A	02/JULY/2019	Department Layout based on Request DC-102162
REV	DATE	MODIFICATIONS
A mandatory component of this drawing set is the GE Healthcare Pre Installation manual. Failure to reference the Pre Installation manual will result in incomplete documentation required for site design and preparation.		
Pre Installation documents for GE Healthcare products can be accessed on the web at: www.gehealthcare.com/siteplanning		
GE does not take responsibility for any damages resulting from changes on drawings made by others. Errors may occur by not referring to the complete set of final issue drawing. GE cannot accept responsibility for any damage due to the partial use of GE final issue drawings, however caused. All dimensions are in millimeters unless otherwise specified. Do not scale from printed pdf files. GE accepts no responsibility or liability for defective work due to scaling from these drawings.

INNOVA IGS 530

**Hospital Municipal de Aparecida de Goiania
Aparecida de Goiania, GO
Brazil**

OPTION 1:

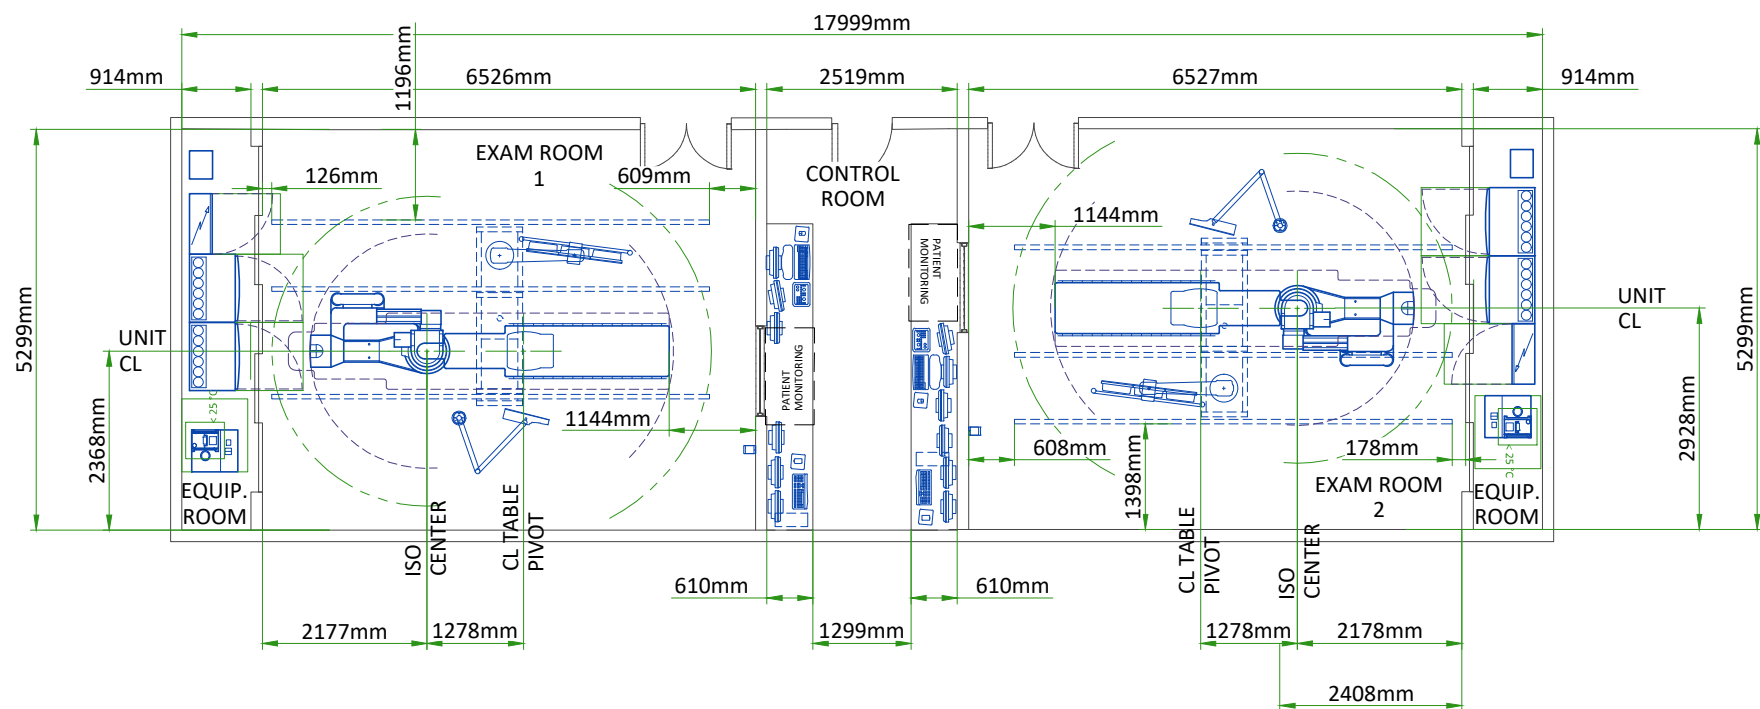
- THIS LAYOUT REFLECTS ROOM SIZES AS PROVIDED IN THE SUPPLIED SKETCH
- EXAM ROOM IS EXTREMELY TIGHT. IT WILL BE VERY DIFFICULT TO GET BETWEEN THE TABLE AND CONTROL ROOM WALL
- CONTROL ROOM IS VERY NARROW. VERY SHALLOW COUNTERS SHOWN. TIGHT SPACE BETWEEN COUNTER TOPS FOR OPERATORS
- LONG RAILS SHOWN AS SHOWN IN SKETCH

- THIS LAYOUT REFLECTS EXPANDED ROOM SIZES FOR BETTER CLEARANCES AND EGRESS
- NARROWING EQUIPMENT ROOM AND CONVERTING WALL TO REMOVABLE DOOR PANELS TO ALLOW FOR MORE SPACE IN THE EXAM ROOM
- EXAM ROOM EXPANDED TO ALLOW FOR MORE SPACE BETWEEN THE TABLE AND THE CONTROL ROOM WALL
- CONTROL ROOM SLIGHTLY EXPANDED. ROOM STILL IS TIGHT, BUT BETTER FOR OPERATORS
- LONG RAILS SHOWN - LOCATION ADJUSTED
